## CITY OF HAYWARD AGENDA REPORT

**SUBJECT:** **Update to Report Dated April 14, 2005 for Zone Change No. PL-2004-0418 & Vesting Tentative Tract Map 7554/PL-2004-0417 –Arlene Utal for Chabot Estate Homes (Applicant)/ Greg Silva (Owner) – Request to Change the Zoning From a Single-Family Residential (RS) District to a Planned Development (PD) District and Subdivide 2 Acres to Build 11 New Homes and Renovate the Historic Home**

The Project Location Is at the Easterly End of Cryer Street at Adrian Avenue.

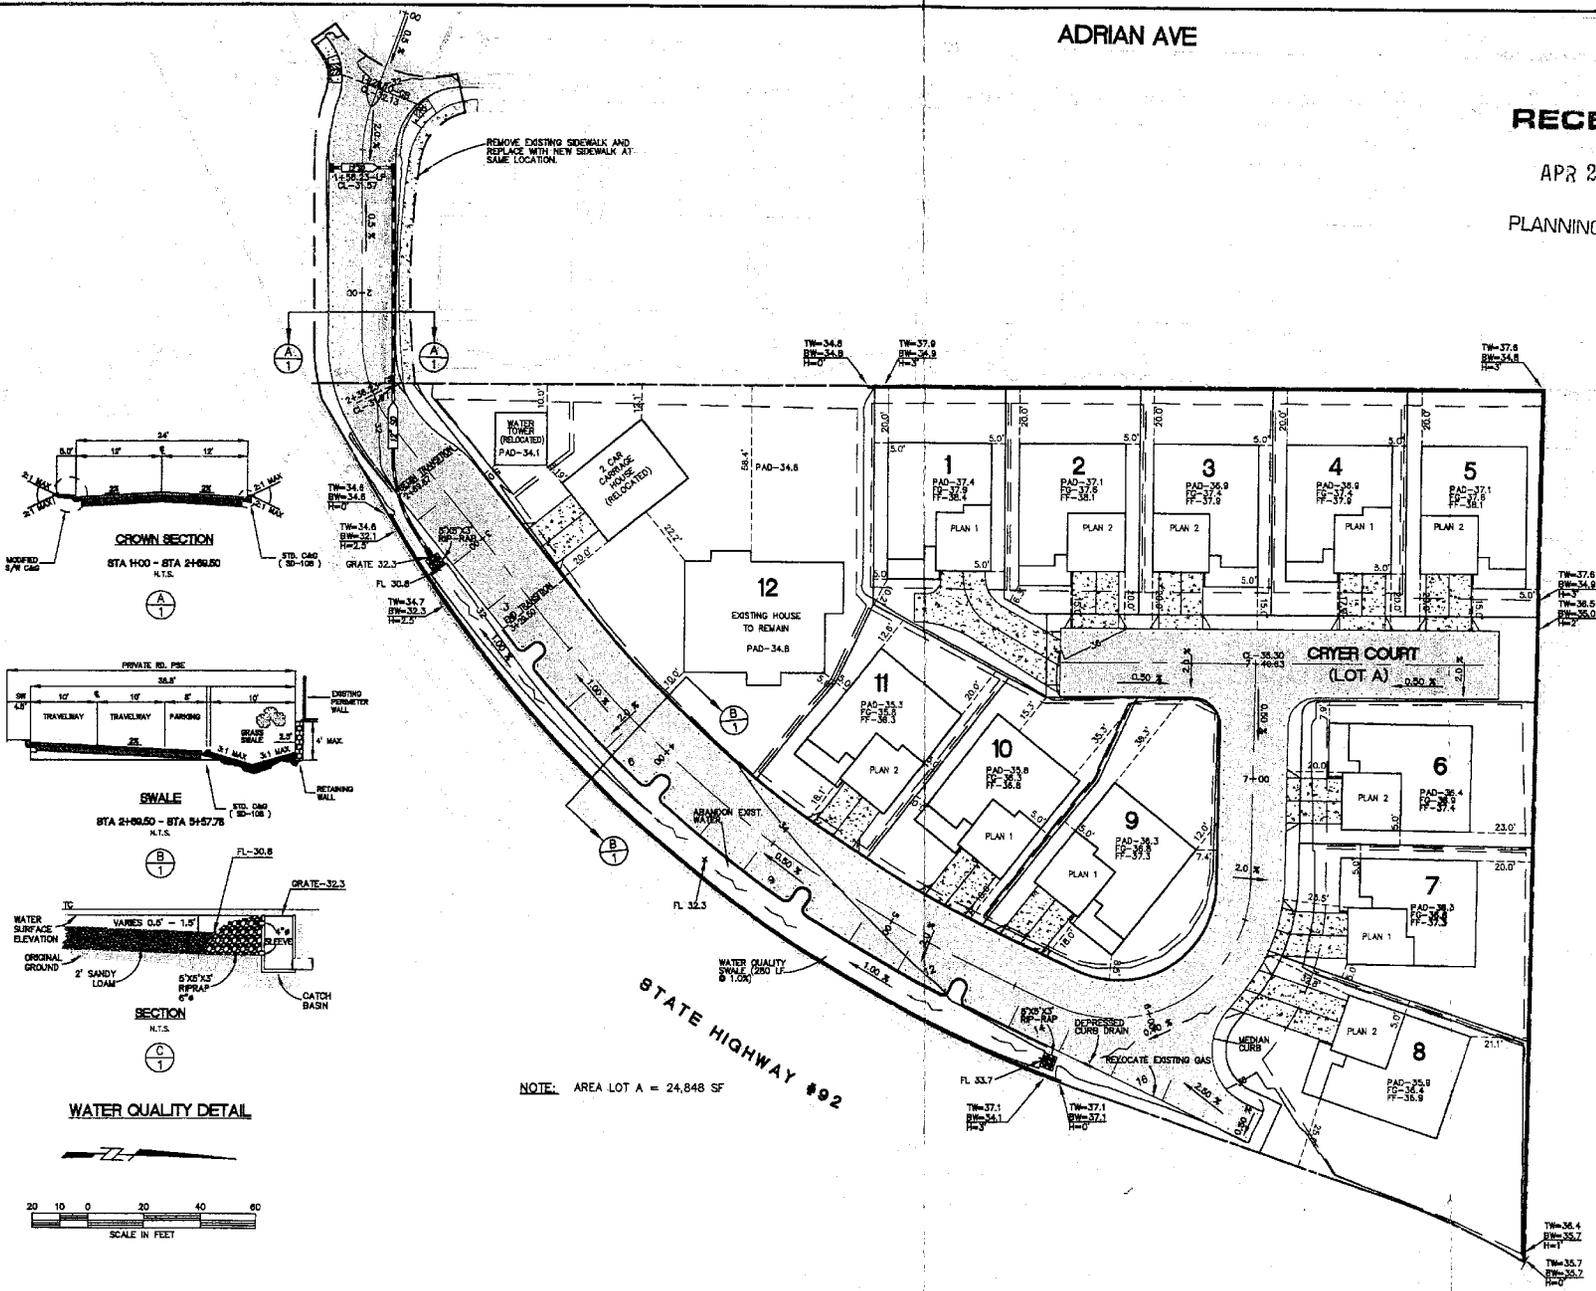
Changes to the site plan include:

- The garage and driveway on Lot 11 is now on the right side to reduce its visibility as one enters the project. However, the 18-foot driveway would be shorter than the City's standard of 20 feet.
- The rear yards of Lots 9 through 11 have been made larger, but at the expense of the turn-around on Lot 1, which would no longer be functional. Also, the rear yards of Lots 10 and 11, along with Lots 1 and 12, still would have noise levels exceeding the General Plan guideline.

Regarding the grassy swale, the hydrology report prepared by the applicant's engineer still does not address the City's landscape and drainage concerns. The area next to the wall needs to include a 5-foot-wide strip for trees and landscaping, which cannot be part of the swale. The calculations indicate that a 10-foot-wide swale is necessary to provide the necessary treatment for the storm runoff, which, when combined with the required landscaped area, would require a 15-foot setback from the sound wall; only 10 feet is proposed.

In order to achieve the necessary cleaning action, the swale must be planted with grasses or a ground cover that is flush to the ground. Approval of the project as it is currently designed would likely mean that the screen trees normally required at the perimeter of the site could not be planted and any landscaping planted to soften the sound wall would be minimal.

A more sensible approach would be our suggestion to flip the homes on lots 10 and 11 so the garages are on the right side as one drives down the street. By rotating the units on lots 10 & 11 as explained above we will be able to put an 18' driveway on lot 11 and eliminate the extra parking space next to the unit.

The staff report states that Lot 11 has only a 5-foot front yard setback where 20 feet is required. We have now corrected that with an 18' driveway and putting the garage on the right side of the lot.

In response to the Staff Report, we have adjusted the bulb-outs along the sound wall to be a minimum interior width of 5 feet.
